**ZONING AMENDMENT
& SUBDIVISION STAFF REPORT****Date: December 3, 2015****APPLICANT NAME**

Addition to Regal Investments Subdivision

LOCATION3500 & 3520 Government Boulevard
(North side of West I-65 Service Road South, 510'± East of
Lakeside Drive).**CITY COUNCIL
DISTRICT**

CONTEMPLATED USESubdivision approval to create 2 lots, and Zoning approval
to rezone the site from B-3, Community Business, to I-1,
Light Industry, to eliminate split zoning.**It should be noted, however, that any use permitted in
the proposed district would be allowed at this location if
the zoning is changed. Furthermore, the Planning
Commission may consider zoning classifications other
than that sought by the applicant for this property.****REASON FOR
REZONING**Increased need for industrial sites in addition to sites that
are available.**TIME SCHEDULE
FOR DEVELOPMENT**

DETAIL SITE PLAN

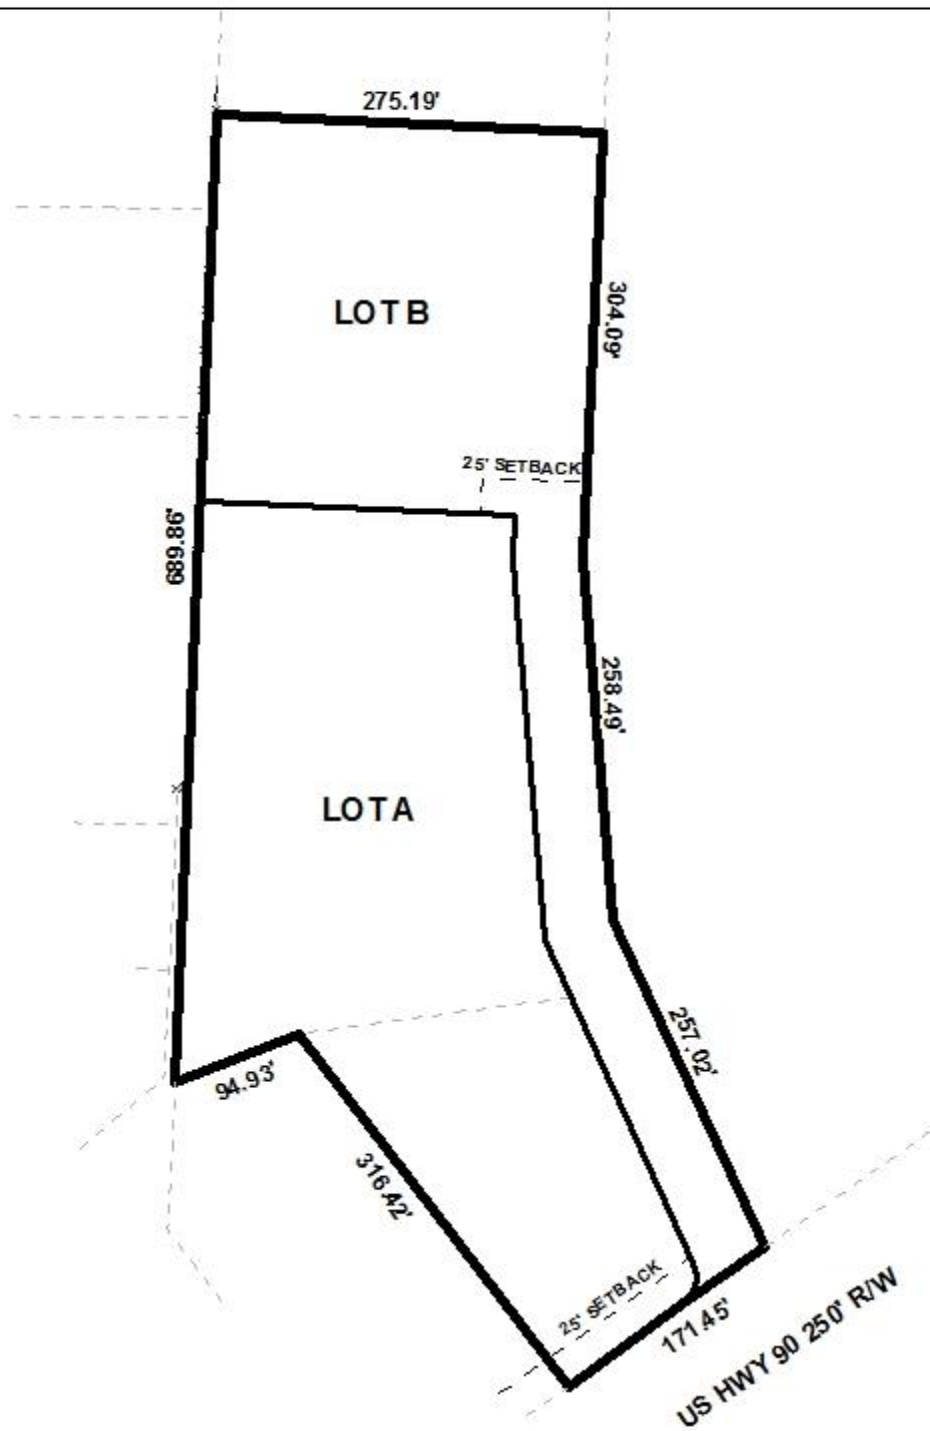
Proposed Lot A is irregularly shaped and may be regarded as a "flag" lot with a "pole" providing frontage onto Government Boulevard 99.46'± in width; its length is 316.42'± in the West and 556.84'± in the East. Proposed Lot B is also a "flag" lot with a "pole" providing frontage onto Government Boulevard that is 71.99'± wide and 556.84'± long; the width of the remaining "pole," it should be noted, is 50' wide. Flag lots are generally discouraged by Section V.D.1. of the Subdivision Regulations; however, they are permitted only in those locations where varied and irregularly-shaped lot designs are common and the informality of design is consistent with other lots in the vicinity. There do not appear to be many flag lots in the area, but the Planning Commission's previous approval of the Regal Investments, LLC Subdivision in 2007, of which Lot 1 was a flag lot, sets a precedent for the approval of this subdivision, thus making the waiver of Section V.D.1. of the Subdivision Regulations appropriate; however, a note should be required on the Final Plat stating that further re-subdivision of Lot B will not be allowed until additional public street frontage is provided.

The proposed lot sizes are provided in square feet and acres; however the width of the "pole" of the proposed "flag" lot A is large enough to be potentially re-subdivided and, in accordance with the Subdivision Regulations, is not exclusive of unusable land, thus contributing to a maximum depth more than 3.5 times the width of the lot at the potential building setback line; a waiver of Section V.D.3. will be required for approval. Irrespective of the width to depth ratio, the proposed lots exceed the minimum size requirements and, as is mentioned, are appropriately labeled along with the 25' minimum building setback line. This information should be retained on the Final Plat, if approved.

As a means of access management, a note should be placed on the Final Plat stating that the lots A and B are limited to one shared curb cut to Government Boulevard, with its size, design and location to be approved by Traffic Engineering and ALDOT, and conform to AASHTO standards.

- 1) Placement of a note on the Final Plat stating that further re-subdivision of Lot B will not be allowed until additional public street frontage is provided;

- 2) retention of the 25' minimum building setback line along all frontages;
- 3) retention of the lot sizes in square feet and acres on the Final Plat, or the furnishing of a table on the Final Plat providing the same information;

- 4) placement of a note on the Final Plat stating that lots A and B are limited to one shared curb cut to Government Boulevard, with its size, design and location to be approved by Traffic Engineering and ALDOT, and conform to AASHTO standards;

SITE PLAN

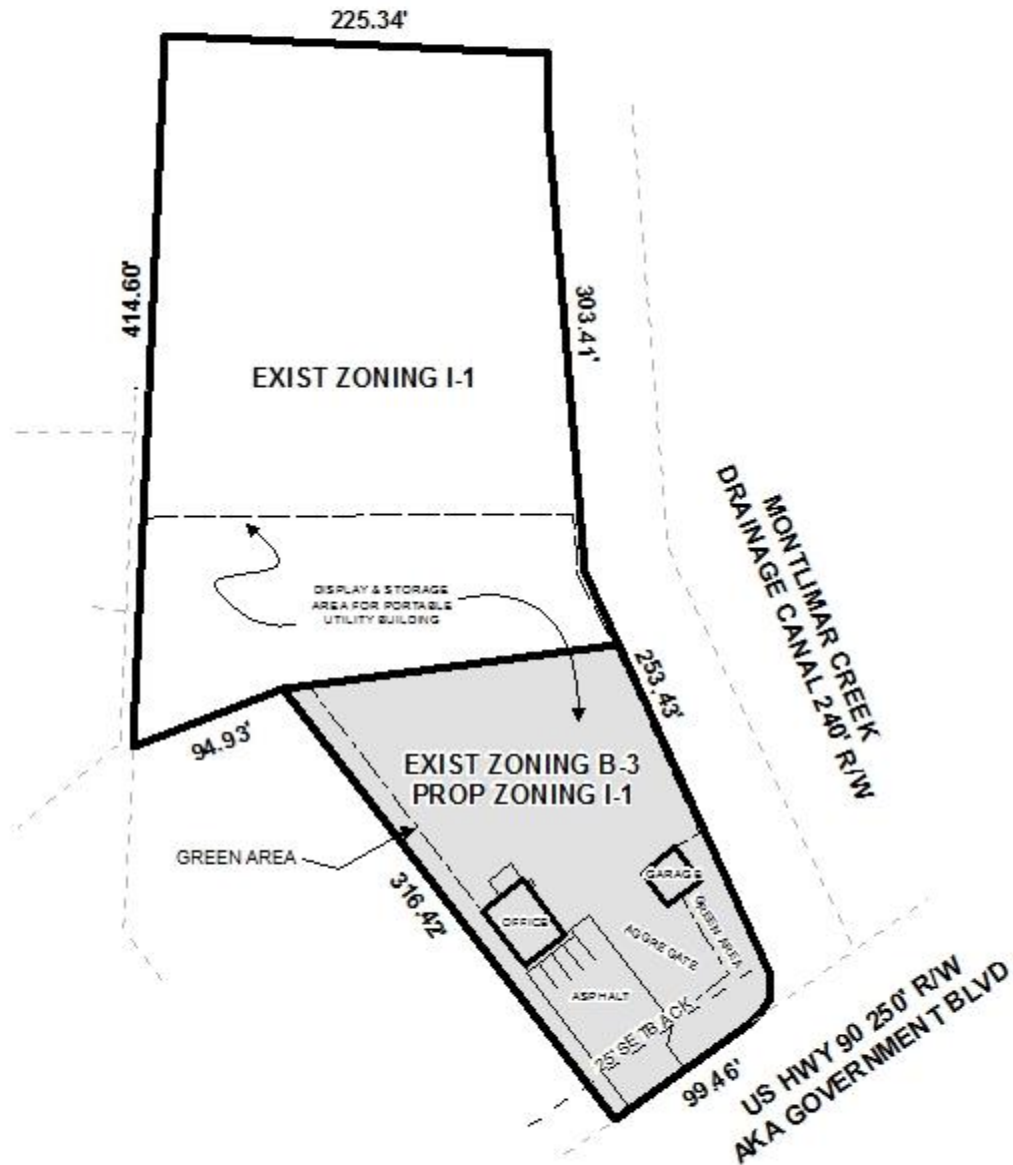
The site plan illustrates an existing 1,200 s.f. office building, thus requiring four parking spaces, one of which must meet the requirements for van accessible parking; while the four spaces meet the requirements regarding surfacing, and stall length and width, no van accessible space is

provided. If approved, a revised site plan illustrating at least one van accessible space, whose stall length is at least 18' long, and whose stall width is at least 9' with an 8' wide access aisle, will be required.

A dumpster is not depicted on the site plan and one is not discernible in recent aerial photos. Any dumpster placed on the property must be in compliance with the current enclosure and sanitary sewer connection requirements of Section 64-4.D.9. of the Zoning Ordinance, and must be illustrated on any revised site plan(s), or placement of a note on the site plan stating that curbside pickup will be utilized, if approved.

It should be noted that recent aerial photos depict a portion of the development on proposed Lot A encroaching on proposed Lot B; if approved, the applicant would be required to eliminate shared access between the lots or submit to the Planning Commission an application for Planned Unit Development approval.

- 3) revision of the site plan to illustrate at least one ADA compliant, van accessible handicap parking space;
- 4) revision of the site plan to illustrate sidewalks along all street frontages, or Planning Commission approval of a Sidewalk Waiver;

- 5) revision of the site plan to illustrate a dumpster in compliance with the current enclosure and sanitary sewer connection requirements of Section 64-4.D.9. of the Zoning Ordinance, or placement of a note on the site plan stating that curbside pickup will be utilized;

- 6) revision of the site plan to illustrate that shared access between Lot A and Lot B has been eliminated, or Planning Commission approval of a Planned Unit Development to allow shared access;
